Interactive comment on “The effect of water storage change in ET estimation in humid catchments based on Budyko framework and water balance models” by Tingting Wang et al.

Tingting Wang et al.

Received and published: 9 June 2017

Fig. 1. Figure 5 The box plot of R^2 between monthly ET_{wb} and ET_{budyko} using the extended Budyko equation, i.e., $P-\Delta S$ as equivalent P , and ΔS is obtained from abcd model.

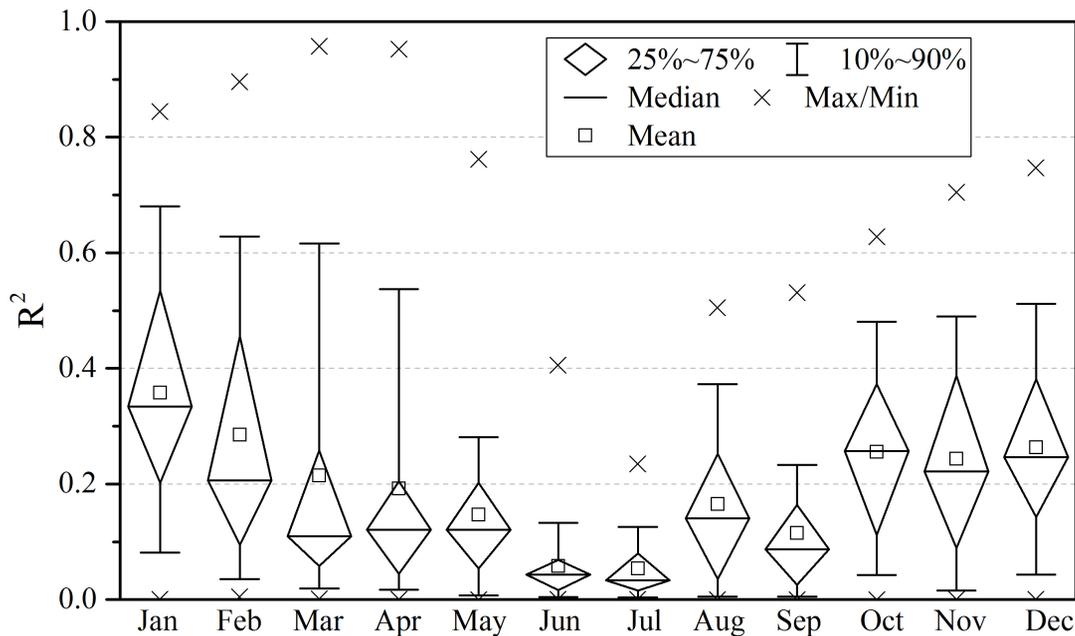
The writing of this paper needs a lot of improvement, and can benefit strongly from a native speaker rigorously rewriting it. I made a long list of suggestions for the first 50 sentences, but this list is not exhaustive (even not for this small part of the manuscript). In its current stage I cannot fully judge the scientific merit of the contribution because the I do not always understand the interpretation of generated results. The paper does not address anything sufficiently novel. The main conclusion that water storage changes can be significant at annual time-scales is already well known. In addition, some of the methods that the paper uses to estimate ET (Budyko and a water balance

accounting) have been extensively reported to be only applicable at longer time-scales. Consequently, I do not see why the paper is relevant to HESS. The manuscript is not based on sound reasoning that can be easily followed. While this may be a linguistic issue, since the authors are (I assume) no native English speakers, it hinders me from properly judging the scientific merit of this work.

a) We have added the result about the effect of ΔS on annual ET estimation based on Budyko framework in section 3.3. It shows that almost no improvement has been made in annual ET estimation based on the extended Budyko equation (Figure 6), which uses $P-\Delta S$ as 'equivalent' precipitation at monthly timescale through high R^2 achieved (Figures 5 and 6), which is due to the seasonal pattern within the year.
